CIRCUIT OF 7 VALVE BATTERY MODEL.

CIRCUIT OF AUDIO SECTION OF 7 VALVE BATTERY & 8 VALVE D.W. BATTERY MODELS (MODELS E & D) AS FROM 1st AUGUST 1935.

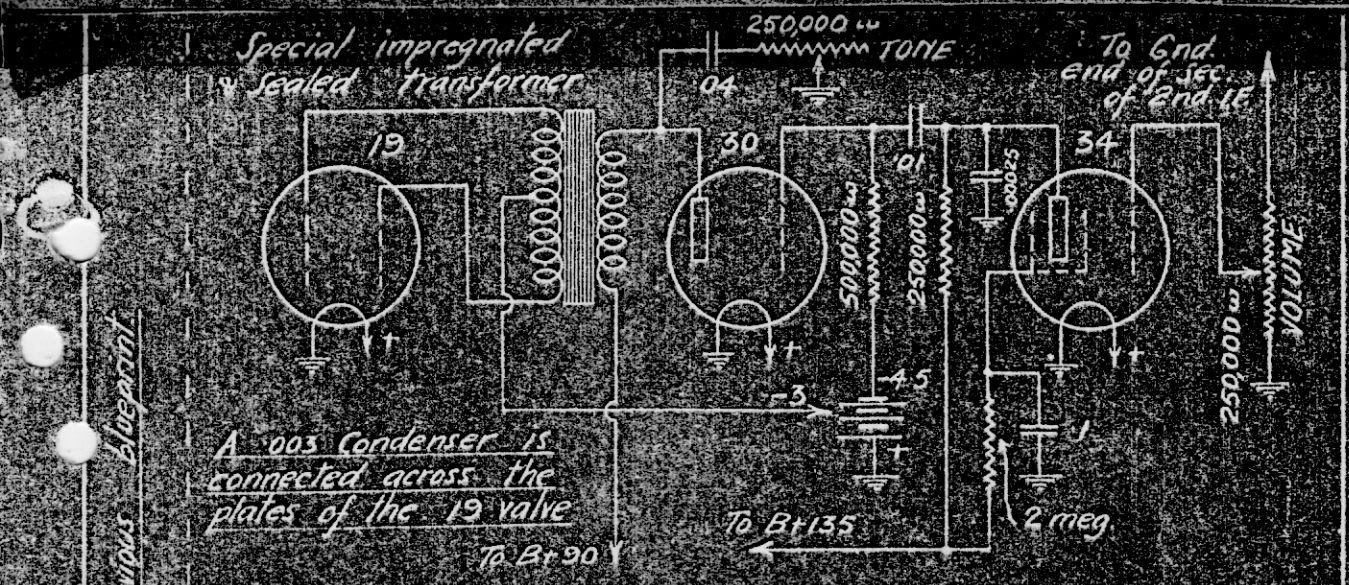
A .003 Condenser is connected across the plates of the 19 valve

The B+ feed to O.S.C. valve is taken to B+67.5 instead of B+90 in the 8 v. D.W. model.
